Taylorcraft

Taylorcraft Aviation Corporation

SERVICE BULLETINS

Service Bulletin Index

Bulletin No. 21

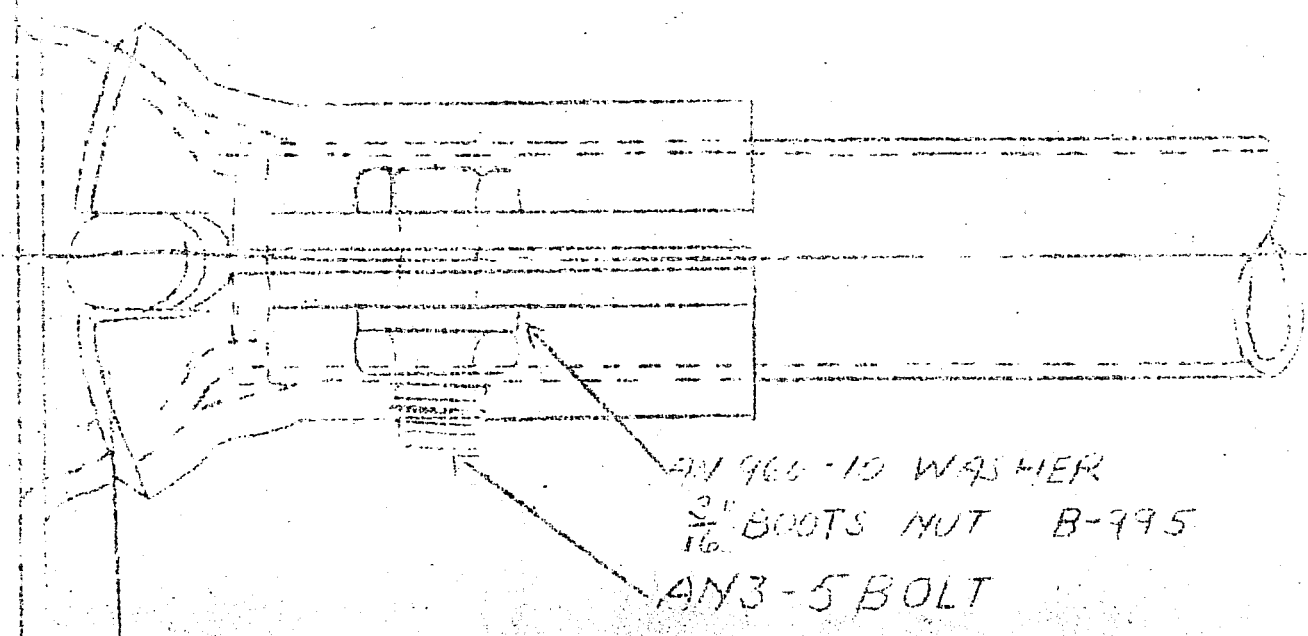
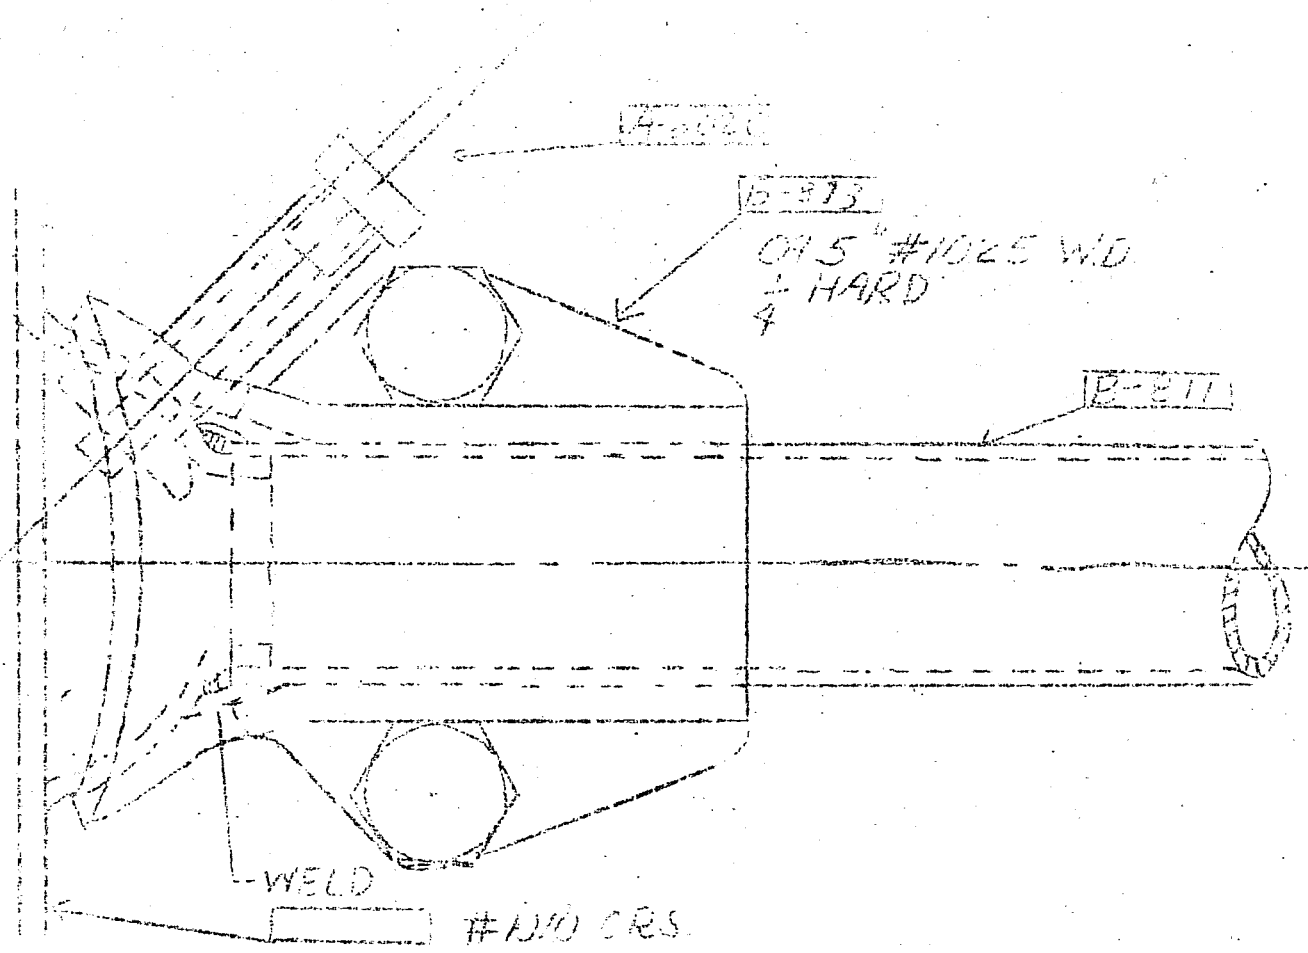
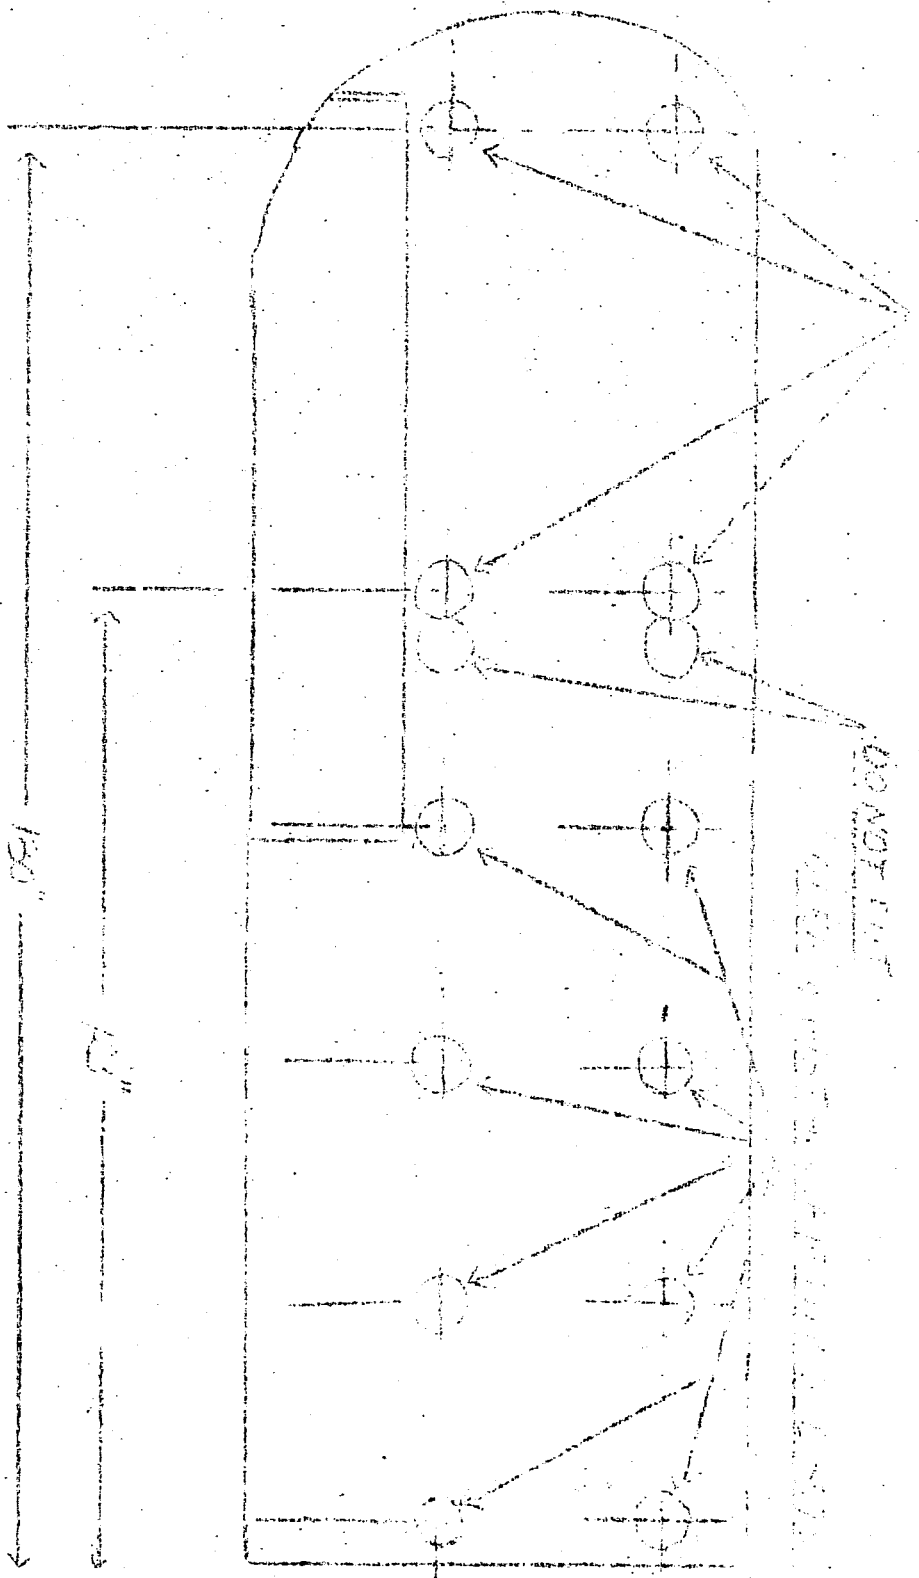
The enclosed print shows the drag strut reinforcing fitting installed in the wing. There is an inspection opening at each strut foot intersection except at the end of the outer bay.

Enclosed with the shipment of parts are four extra rings for each wing, to be installed on the under surface of the wing, as shown on the accompanying print. When these have been installed, cut out the circular pieces of cloth inside the twelve rings as shown on the sketch but it is not necessary to cut the two rings nearest the lift strut fittings.

The reinforcing fitting is in two halves. Place the bolts in the upper half and install the upper half of the fitting on the tube and over the drag strut foot, so that it lies over each brace wire fitting. Put the lower half in place using two washers under each of the Boots self-locking nuts. The bolt will not turn, but the washers under the nut permits the nut to turn. The nut is self-locking and does not need a cotter pin. When installing, tighten the bolts snugly, then tap the reinforcing fitting out toward the spar, making sure that it is in contact with the drag strut foot underneath. It is also important to watch that the gap in each side of the fitting is uniform, because if one side is pulled up tighter than the other, it is apt to bind on one wire and leave the other one loose and cause the fitting to lose some of its efficiency. Then pull the bolts up real tight as it is important that this fitting does not slide along the tube.

Bulletin # 22

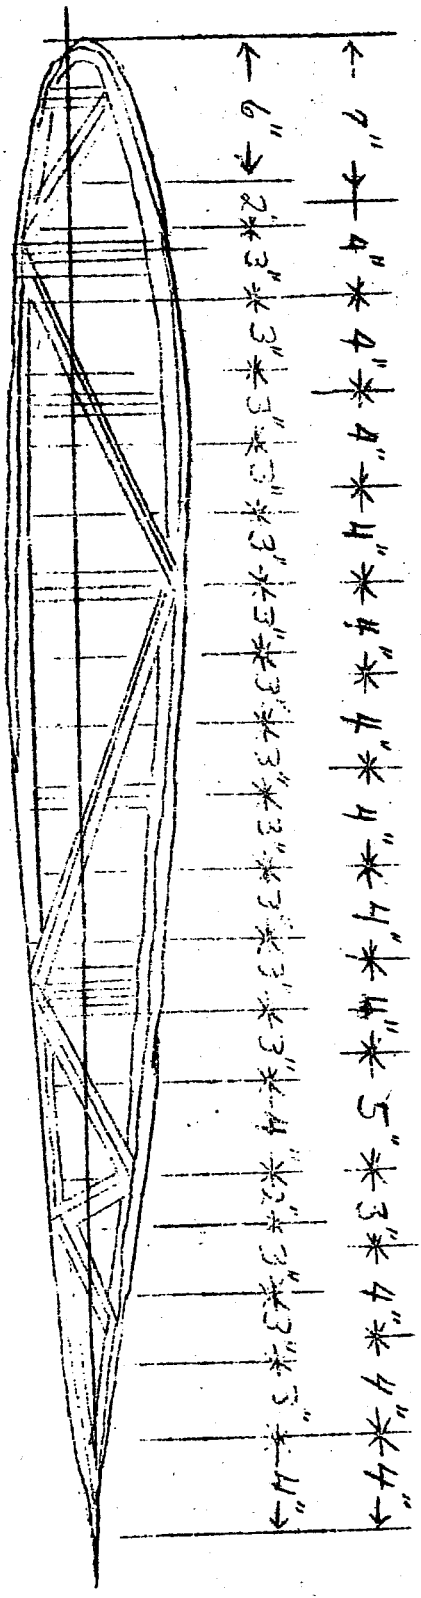
It has been brought to our attention that in a few instances the rib stitching in the wings have become chafed and broken, creating a hazard while engaged in high-speed maneuvering.

Therefore, we believe it urgent that you immediately inspect the rib stitching on the wings of your airplane, and if any stitches are found broken that they be immediately re-stitched.

A 6-U linen rib stitching cord should be used. The first three ribs from the wing butt should be stitched every three inches starting from a point eight inches behind the leading edge of the wing, and the remainder of the ribs should be stitched at four inch intervals beginning at a point seven inches behind the leading edge.

It is not necessary to install the reinforcing tape under the stitches, but merely stitch through the standard finish of the wing and install a strip of pink tape over the rib and the stitching.

NOTE - 3" DIMENSIONS ARE FOR FIRST THREE RIBS FROM ROOT
 4" DIMENSIONS ARE FOR ALL RIBS FROM THREE ON OUT

Bulletin # 23

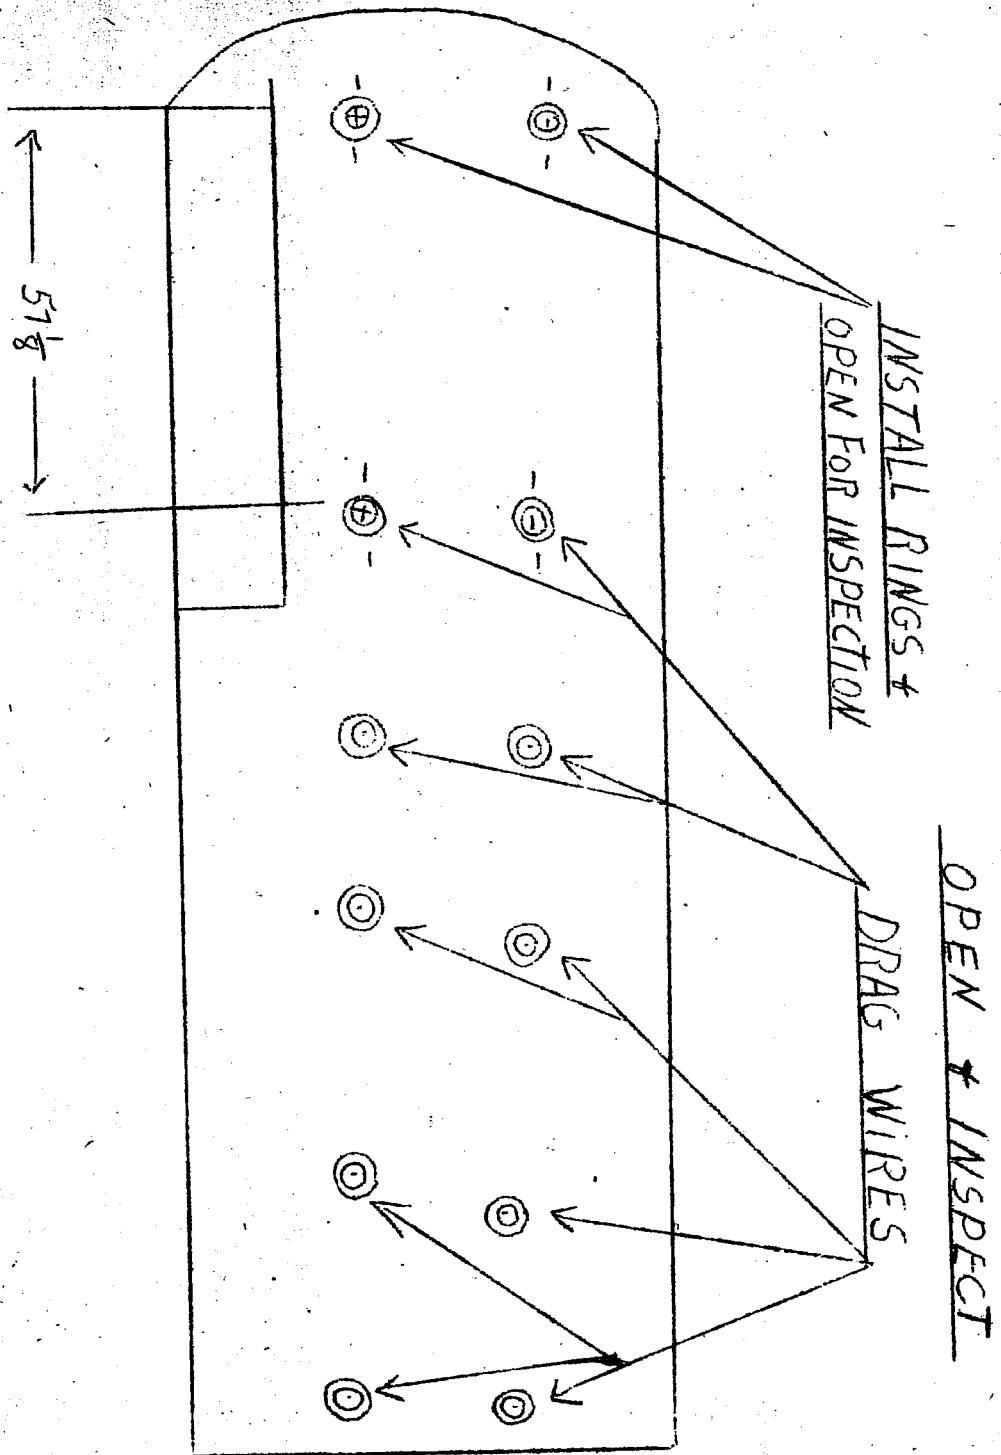
It has come to our attention that on the above group of ships the wing drag wires may not have been tightened enough. Therefore, we request that you have the wires checked in your ship and tightened if they are loose.

Cut the circles out of the grommets that are installed on the wings for this purpose as shown on the accompanying sketch. The wires should be rigged by turning the nipple until the wire is tight, but care should be taken not to rig too much initial tension. After the nipples are adjusted, be sure the lock nuts are tightened by holding the nipple and turning the nut.

BULLETIN #24

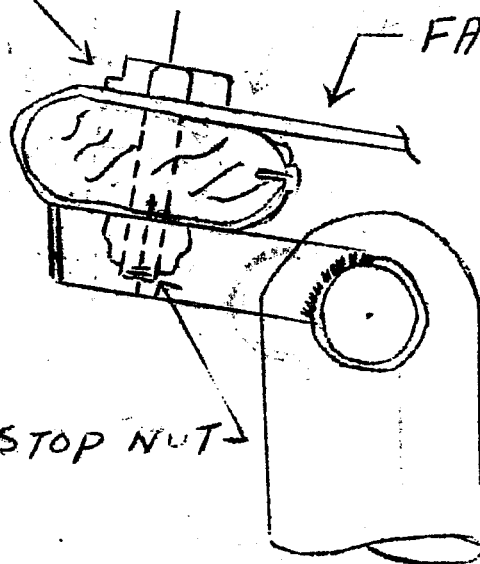
It has come to our attention that there is a possibility that some operators may be lowering the seat incorrectly to accommodate parachutes.

The seat should never be lowered more than one half turn of the seat bar and the four bolts and washers should always be reinstalled and tightened. These bolts should be checked frequently to see that they are tight. AT NO TIME SHOULD THERE BE LESS CANVAS AROUND THE SEAT BAR THAN SHOWN ON THE ACCOMPANYING SKETCH.

BULLETIN #25

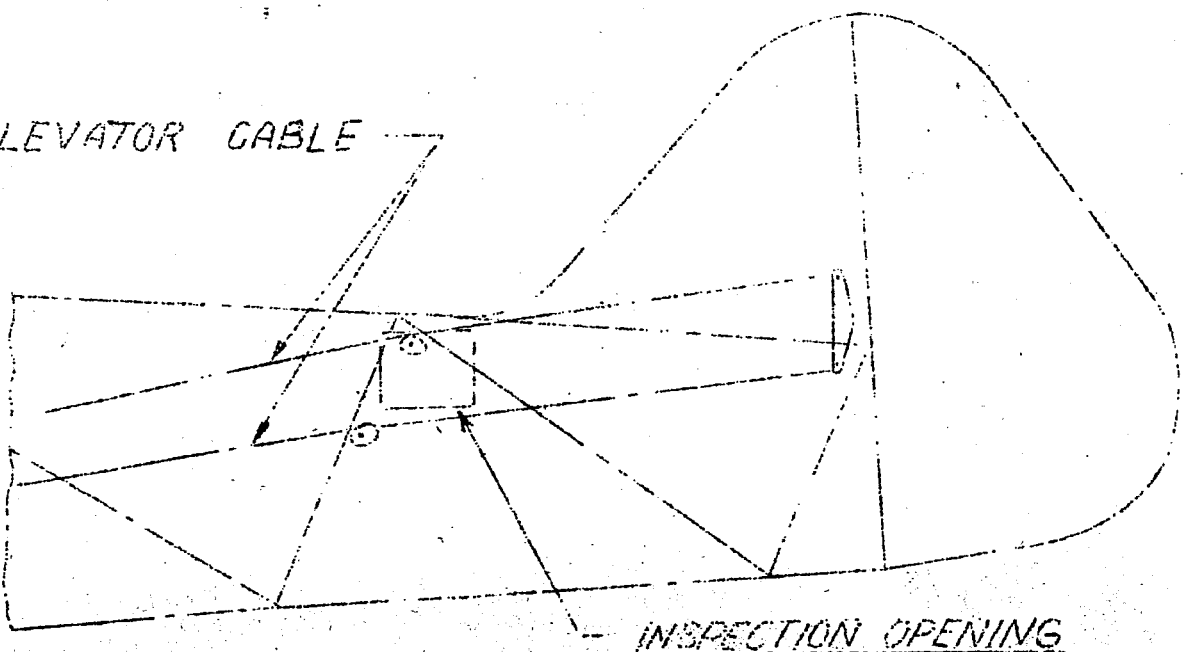
It has come to our attention that there is a possibility of the bushings in the rear elevator control pulleys being too short and not giving the pulley proper clearance in the bracket.

Therefore, we are requesting that you immediately replace the present bushings with the two bushings enclosed and return the enclosed card to our factory at your earliest convenience.

These pulleys are accessible through the inspection openings on the rear of the fuselage, and the location is shown on the accompanying sketch.

BULLETIN #28

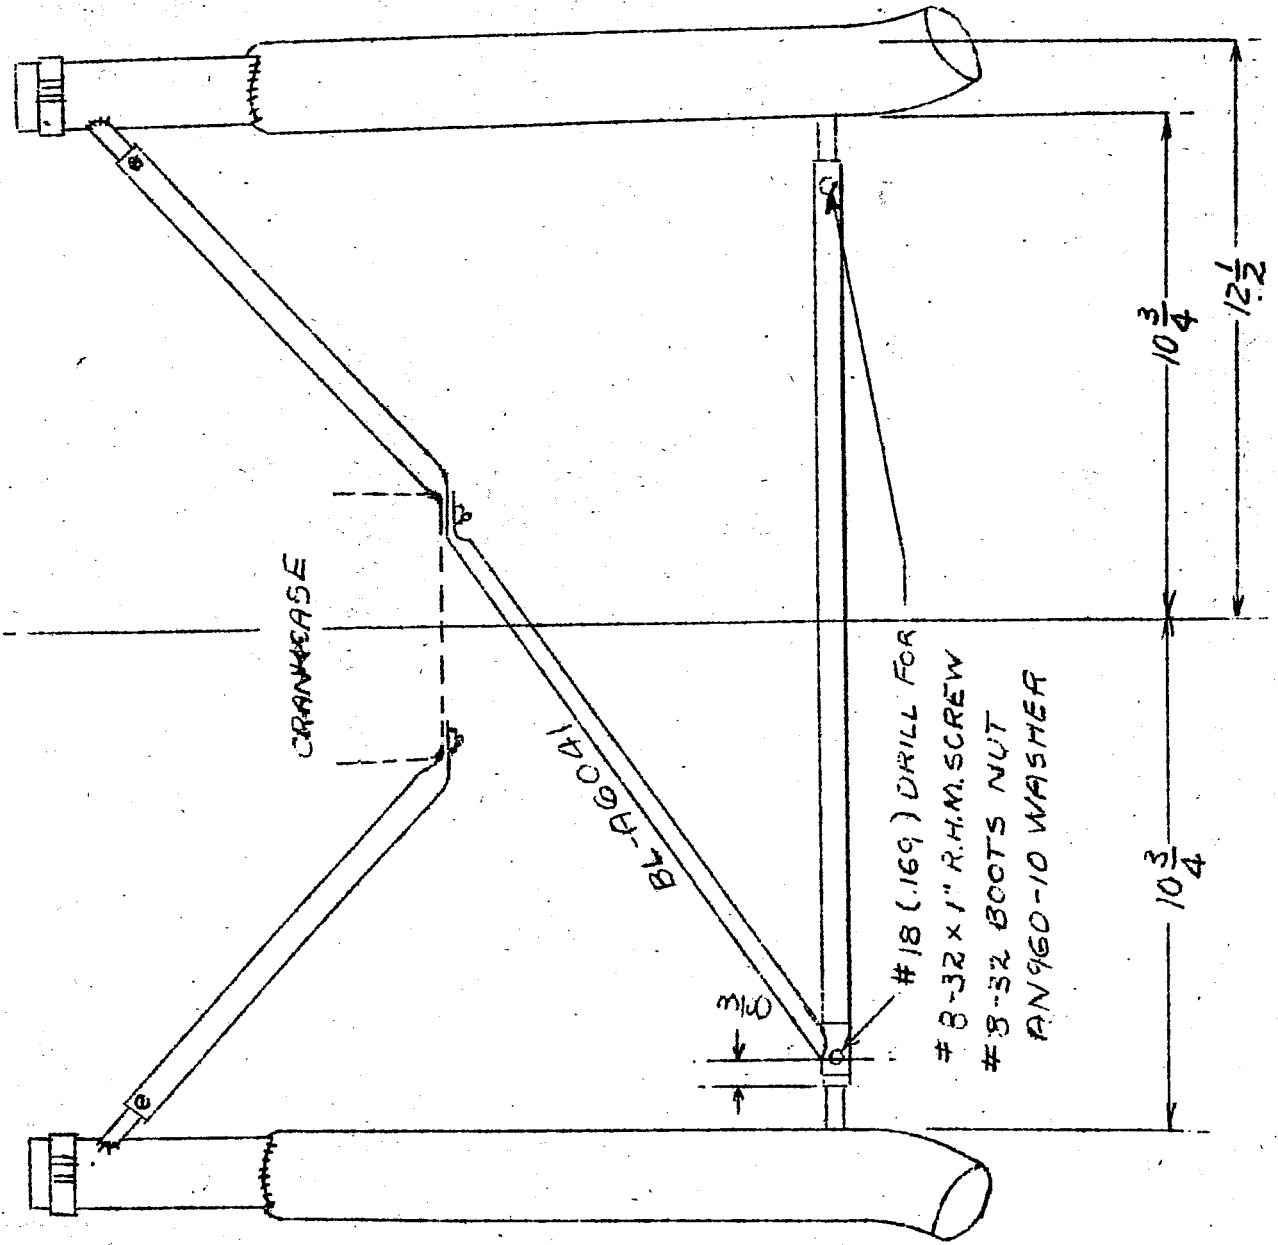
It has come to our attention that the exhaust sleeves on the open cowl Lycoming installations are coming loose from the heads, making it necessary to install new heads or have threaded sleeves inserted in accordance with Lycoming's Bulletin #102.

It has been suggested that this may be due in part to the fact that the lower ends of the exhaust stacks are not anchored even though they are tied together. There is a possibility that during certain rough periods of the engine through oscillation or vibration the lower ends of the stacks may swing and cause the loosening of the exhaust sleeves.

We are recommending the installation of an additional brace from the bracing stud on the bottom of the crankcase on the right side of the engine to the cross tube between the bottom of the stacks where it joins the left stack. This additional brace, we believe, can be made up from the accompanying sketch or can be supplied from our factory at a net price of \$1.00 prepaid.

18 (.169) DRILL FOR
8-32 x 1" R.H.M. SCREW
8-32 BOOTS NUT
AN960-10 WASHER
